ORIGINATION FORM

Proposed Revisions to a Standard Plans Index
(Please provide all information — Incomplete forms will be returned)

Index Number: 521-650
Sheet Number (s): 1
Index Title: Light Pole Pedestal - Wall Coping

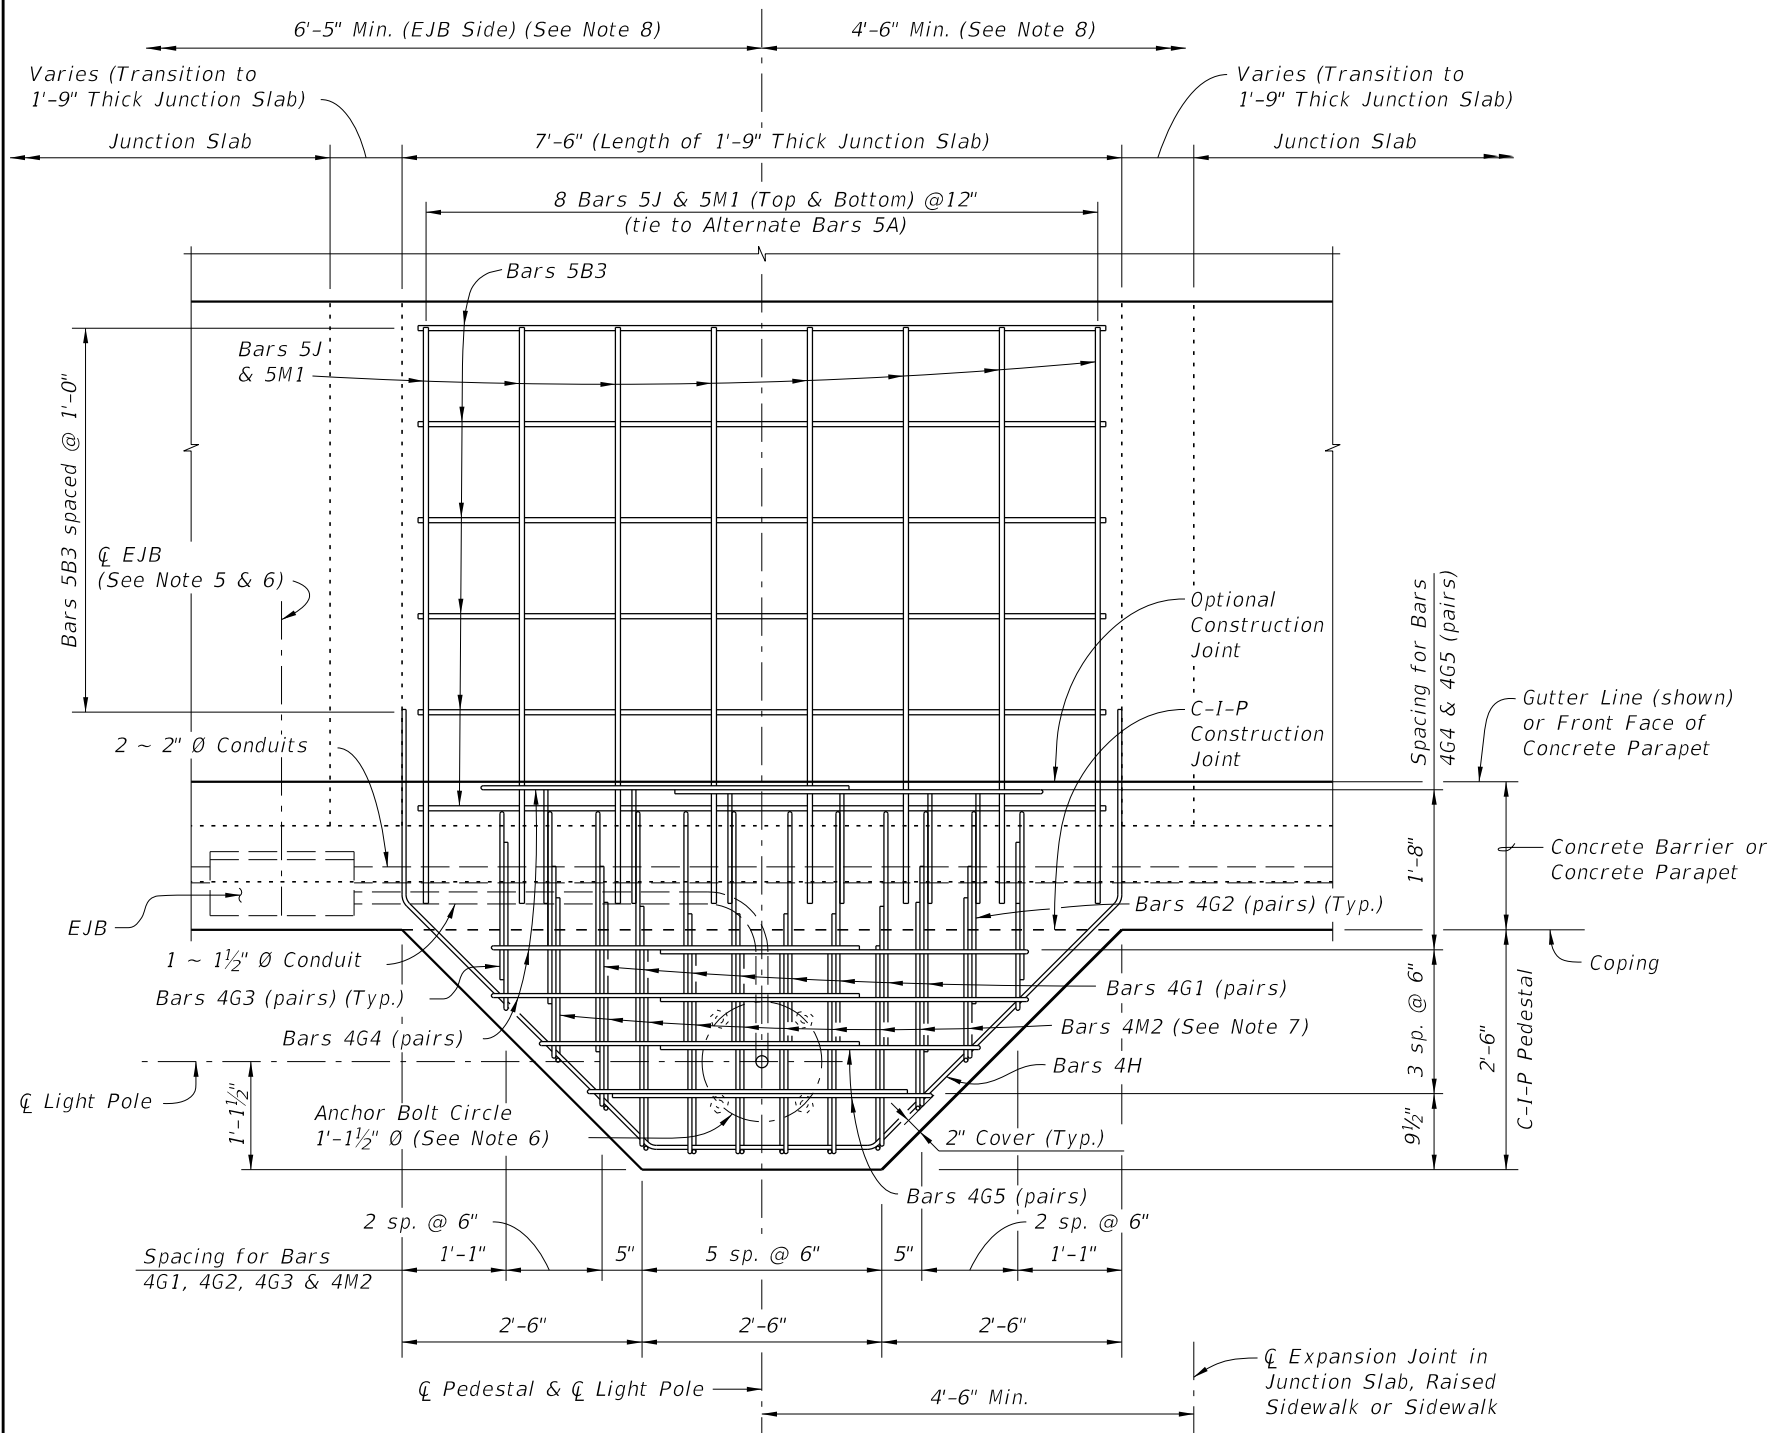
Sheet 1, Note 5: Added reference to Index 630-001 (Conduit Details - Embedded) for information on embedded junction boxes and conduits.

4. ~~Install Anchor Bolts plumb.~~
5. For conduit, EJB and expansion/deflection fitting details, see Utility Conduit Detail Drawings **and Index 630-010.**

Added reference to provide continuity between Standards and improve understanding for designers and contractors wanting to verify that these Indexes share details. This particular topic received designer questions.
